County of Fairfax, Virginia

Re: Proffer Interpretation for RZ 2002-MV-022, Rolling Oaks LLC,
Tax Map 98-4 ((1)) 18 & 98-4 ((3)) 11 pt.: Architectural Elevations

**RE: Rolling Oaks Subdivision
RZ 2002-MV-022
Proffer #8a.**

FRONT ELEVATION UNIT B

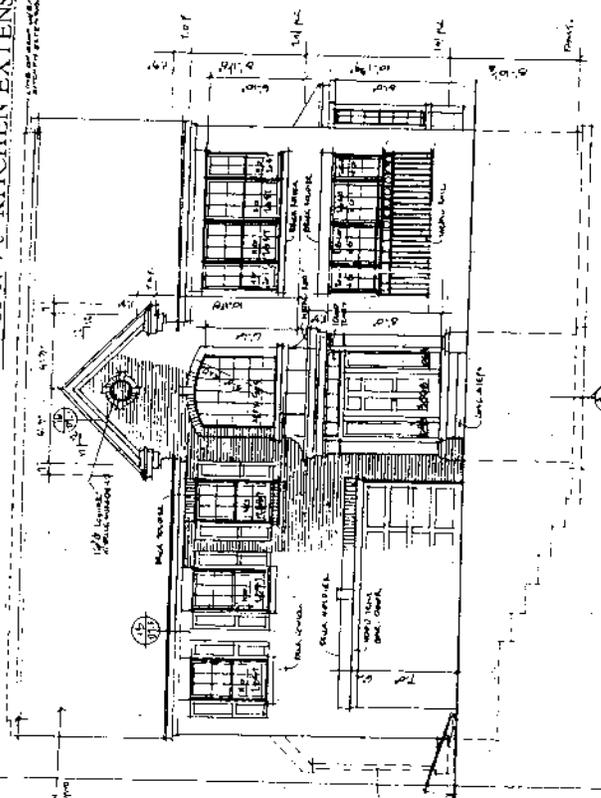
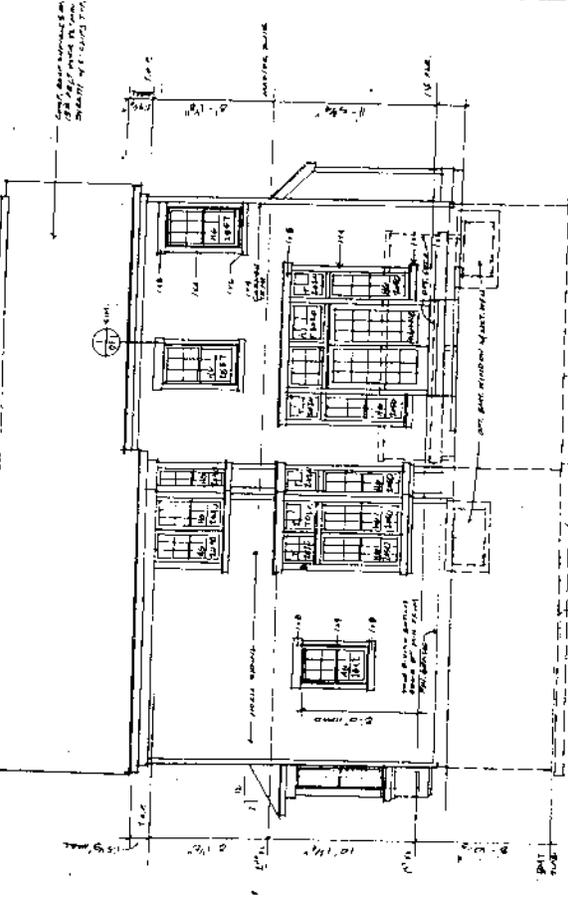
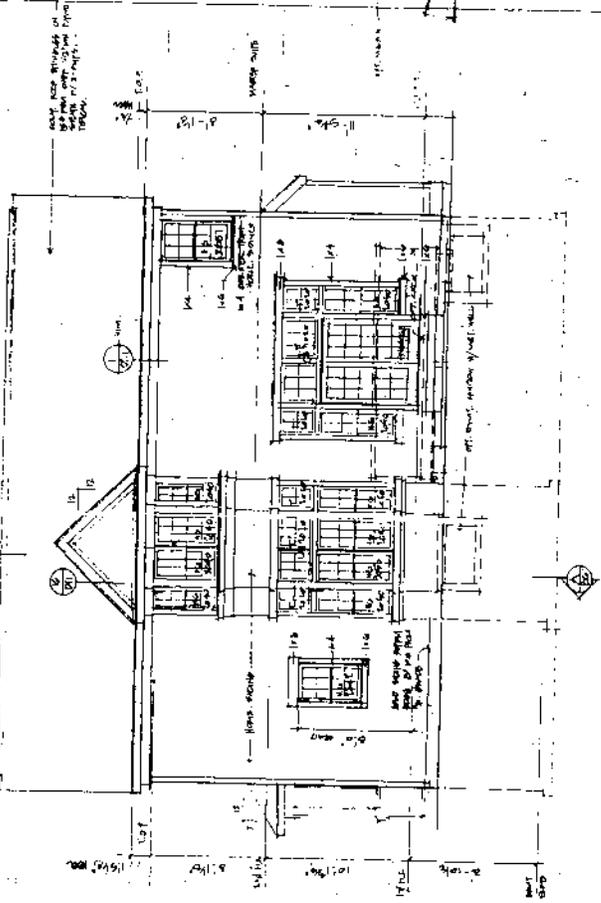
Previous interpretations, issued on April 8, 2005, April 13, 2005, and June 17, 2005, determined that elevations for Unit Types F, F II, O and P were in substantial conformance with the zoning. The current elevations submitted with this request propose additional Unit Types B and C to provide buyers with an additional choice of exterior elevations associated with optional floor plans. Your original letter and proposed elevations provided basic information and illustrations for the proposed exterior design elements. Your supplemental letter and revised elevations confirm the use of brick materials for the unit types and provides architectural elements for the side elevations. According to your letters and additional information provided by you, as stated in a telephone conversation with staff on February 28, 2007, the exterior elevations provided with Unit Types B and C reflect optional floor plans, resulting in a combination of the front entry with the front gable and elimination of a roof line. Previously, the front entry and gable were

separate elements and there were two distinct roof lines. Unit Type B III is also included as an optional floor plan and utilizes the same exterior elevation as Unit Type B. In addition, you stated that the arched architectural elements above the garage doors, as shown on the proffered Exhibit A, will be maintained, irrespective of that shown on the revised elevation illustrations.

1. Per the front elevation, the material shown on the plan is brick and includes brick rowlock and soldier courses which are called out on the plan. The rear and side elevations are horizontal siding which is also called out on each of the sheets. The floored bay window shown on the side elevation of Unit B is a standard feature which provides architectural relief in conformance with the proffer.
2. The front elevation Unit C shall be in brick as shown on the plan enclosed which also calls out brick rowlock and brick surround at the reverse gable louver. The side and rear elevations are horizontal siding. The side elevations shown include standard windows for architectural relief and the standard chimney housing the family room fireplace.
3. All of the windows on side and rear elevations include wide trim boards to accent windows. These include the use of 1x4, 1x6 and 1x8 trim boards.

It is my determination that the revised elevations with notations dated November 8, 2006, submitted with the supplemental letter dated November 8, 2006, and with the commitment to the arched architectural elements over the garage doors per your telephone conversation on February 28, 2007, are in substantial conformance with the proffers. This determination has been made in my capacity as the duly authorized agent of the Zoning Administrator. If you have any questions regarding this interpretation, please feel free to contact Carrie Lee at (703) 324-1290.
